This memorandum has been prepared in response to the request for staff memorandum dated January 24, 2012 in the matter of applications for transfer/new water rights No. 73811, 73834, 63-32499, 61-12095, 61-12096, 63-32703, 61-12256, and 63-33344. The following information was requested:

RE: *Response to IDWR Staff Memo regarding the sufficiency of water supply for water right applications and transfers along the I-84 corridor*

Rebuttal Report of Christian R. Petrich

In the Matter of Application for Transfer No. 73811 (Shekinah Industries); Application for Transfer No. 73834 (Orchard Ranch); Application for Permit No. 63-32499 (Mayfield Townsite); Application for Permit No. 61-12095 (Nevid-Corder); Application for Permit No. 61-12096 (Nevid); Application for Permit No. 63-32703 (Orchard Ranch); Application for Permit No. 61-12256 (Intermountain Sewer & Water); Application for Permit No. 63-33344 (ARK Properties-Mayfield Townsite) before the Idaho Department of Water Resources

Figure 11. Trust area and places-of-use for consolidated applications.

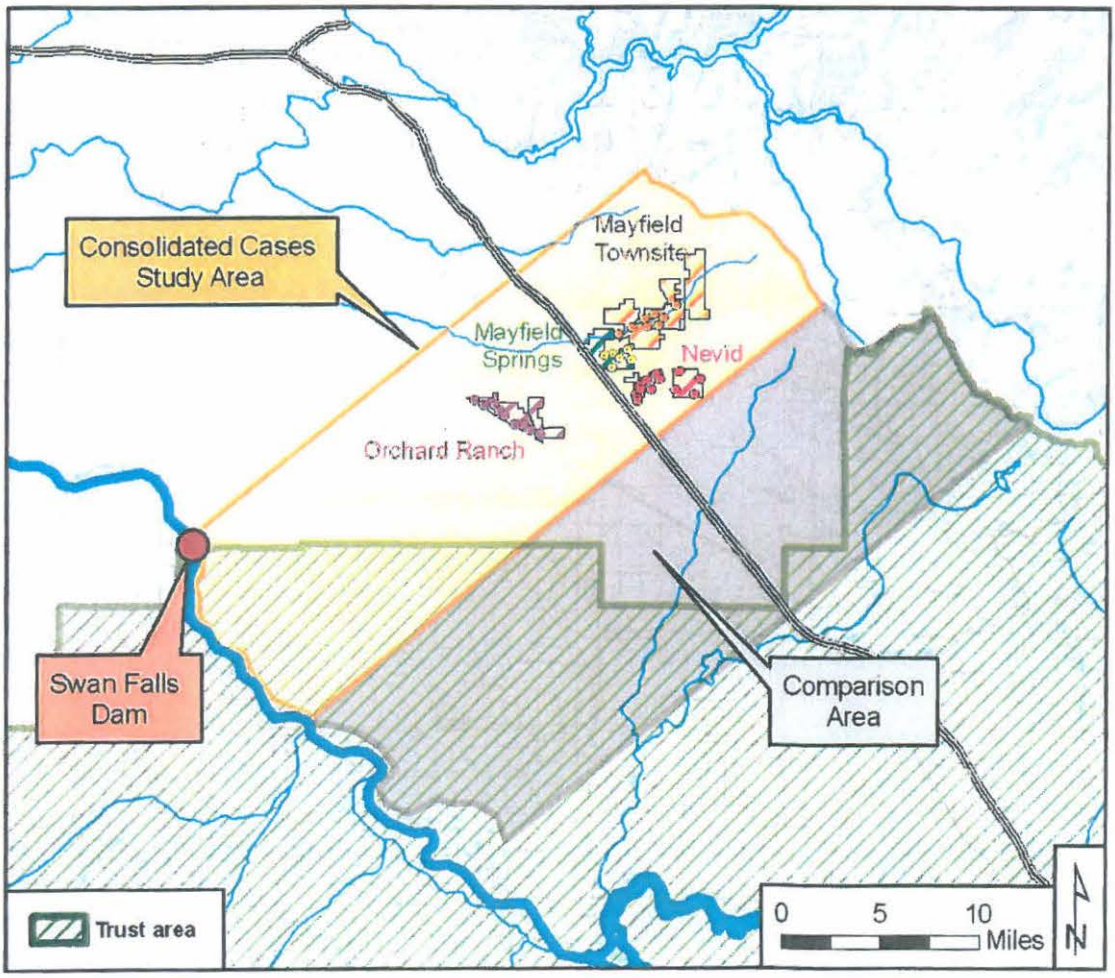
Points of diversion and places of use for the two referenced permits (63-32225 and 61-12090) are not within the trust area boundary defined under IDAPA 37.003.008 (Figure 11). These applications were not protested based on concerns regarding trust water impacts. Consideration of trust water impacts was therefore not required for the processing of these permits. Furthermore, points of diversion and or places of use for applications that are part of this consolidated administrative process (Applications 63-32499, 61-12095, 61-12096, 63-32703, 61-12256, and 63-33344) also lie outside of the trust area (Figure 11).

Figure 12. Snake River minimum flows.

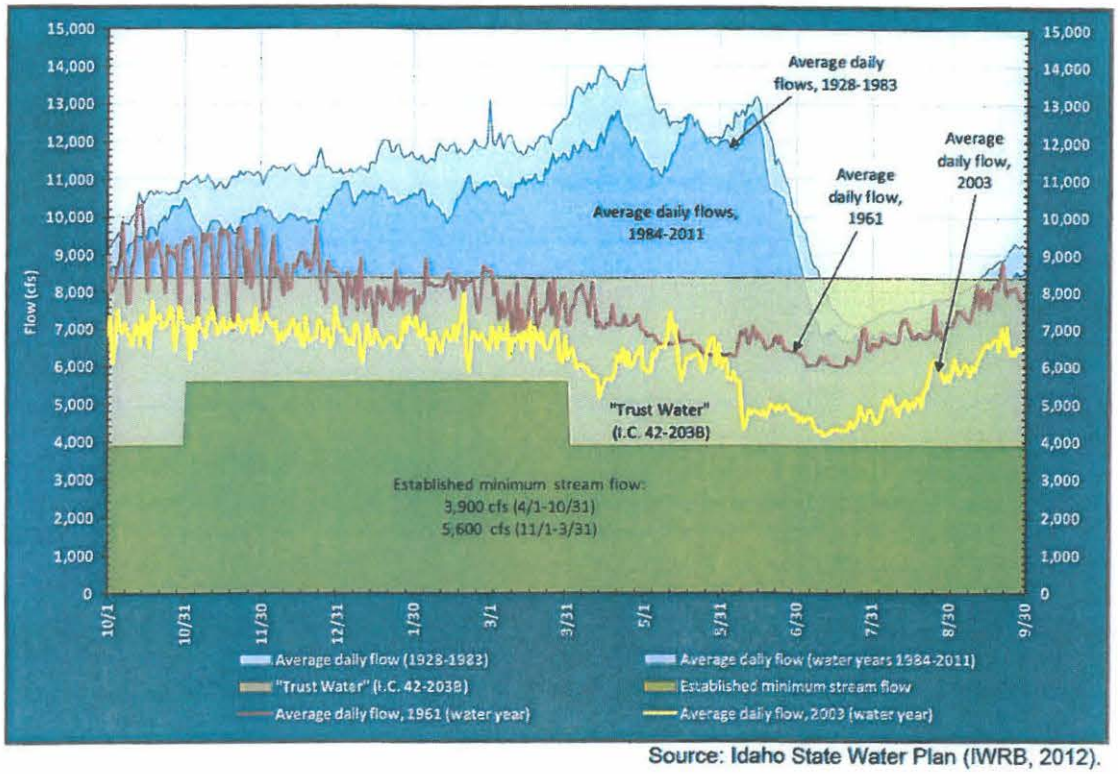
It is important to recognize that average Snake River flows remain well above established minimums. Average daily flows since 1984 (Figure 12) have not only been greater than established minimum flows, but during substantial portions of the year have been greater than the 8,400-cfs generating capacity at Swan Falls Dam. Approval of consolidated-case applications and transfers would represent absolutely no impact to hydroelectric generation during times of the flows greater than 8,400 cfs.

Recent low-flow years (e.g. 2003 – see Figure 12) have seen average daily flows less than 8,400 cfs (but more than minimum flows). However, hydropower rights

Based on the hydrographs in Figure 12, it appears unlikely that a future dip below established minimum flows, if it occurs, would have a long duration. Non-approval of the proposed consolidated-case applications and transfers because Snake River flows may dip below established minimums for a short period of time sometime in the future would preclude the full economic development of the study-area groundwater resource as provided under Idaho Code § 42-226. Furthermore, attempting to prevent a dip in minimum flows by disapproval of these consolidated applications and transfers would be futile because of the relatively small amount of water involved[14].
